PERMIT

SEWAGE DISPOSAL SYSTEM

HOWARD COUNTY HEALTH DEPARTMENT

RE: Building Permit Application
Serial Number: 59532
The Heritage Subdivision - Lot 41
14193 Day Farm Road
Proposed Use: Addition

P 50759E

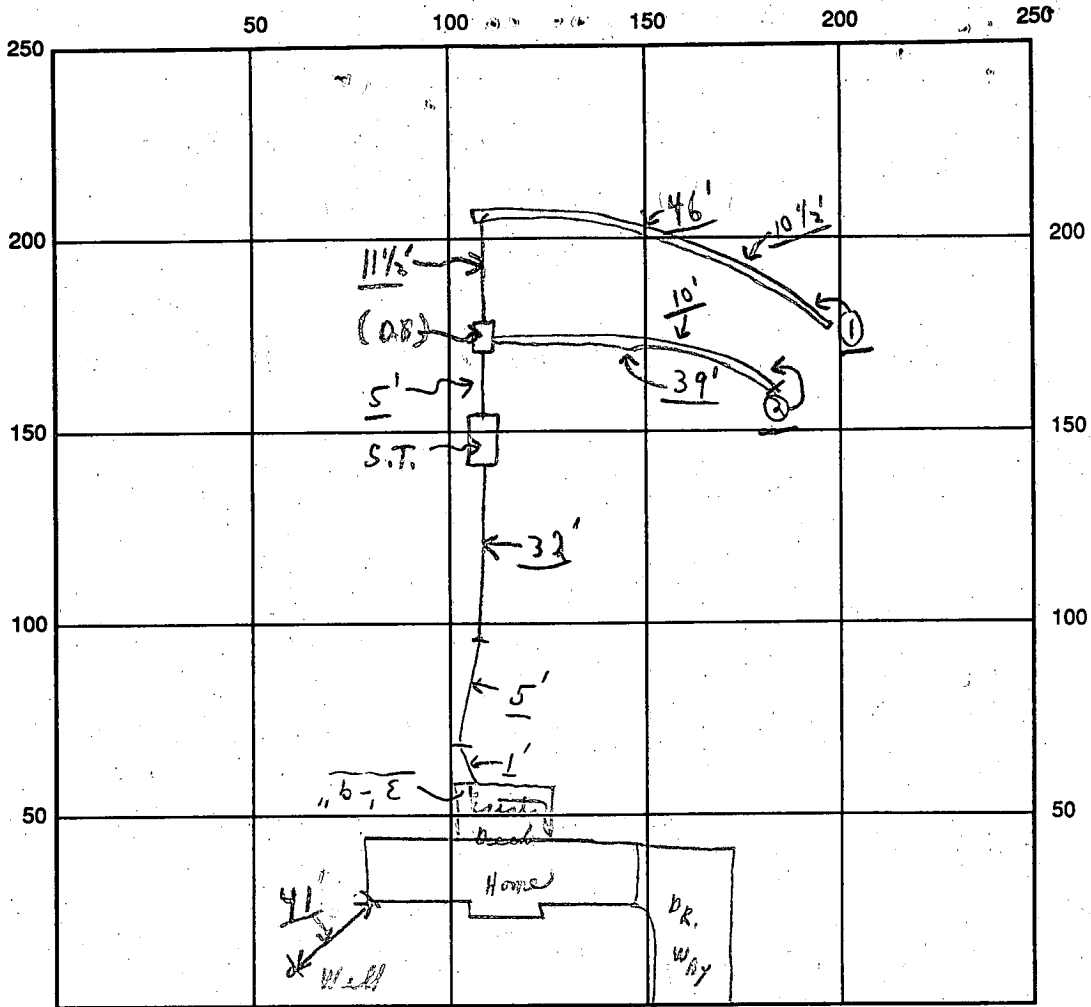
REMARKS: 6/5/95 2 Trenches - new ok for stone, etc;
Note!! old S.T. drain well pumped and filled; partial ckd
6/5/95 with all pipes now in and connected; trenches
complete; Fend.
ckd

A 22377

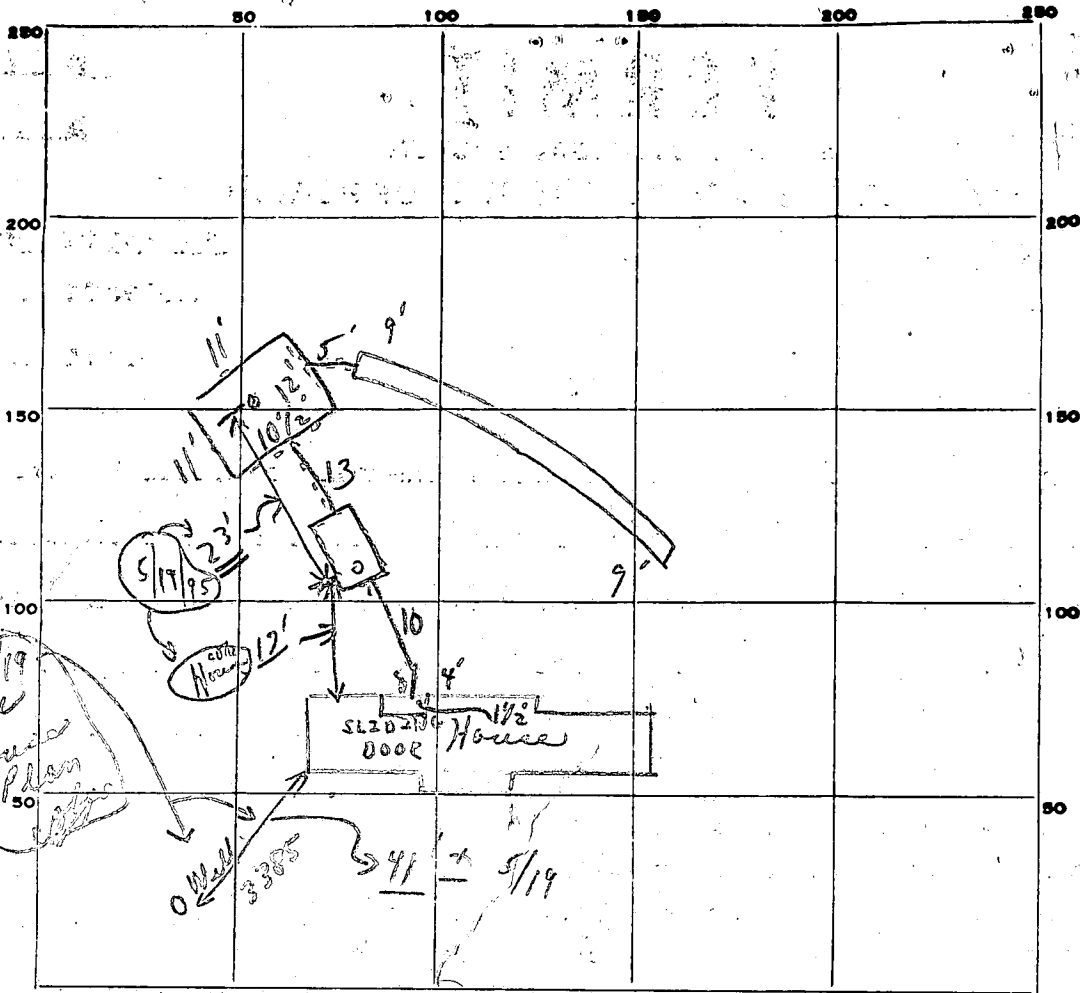
REMARKS 11/6/79 SYSTEM SHORT - ADDED TO TRENCH LENGTH WHILE SANITARIAN ON SITE; OK FOR STONE IN TRENCH. C.B.S.

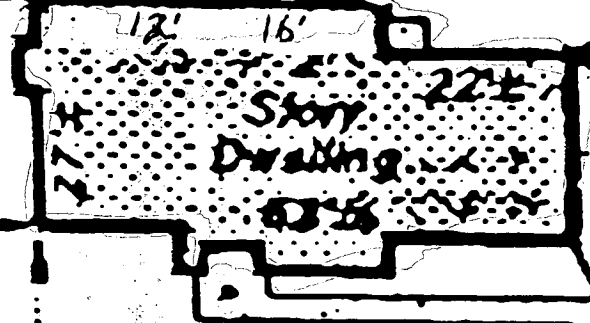
This letter is to advise you that this office cannot recommend approval of the above referenced building permit application at this time.

While water well location is not in conflict with the new addition plan; septic tank appears too close to the proposed construction. The septic tank should be 10 feet plus from the new addition. A field check on May 19, 1995 confirmed that the septic tank was too close to the proposed addition.

*Repaired on 6/5/95
Bldg permit released 6/5/95 (P.M.) CBS*
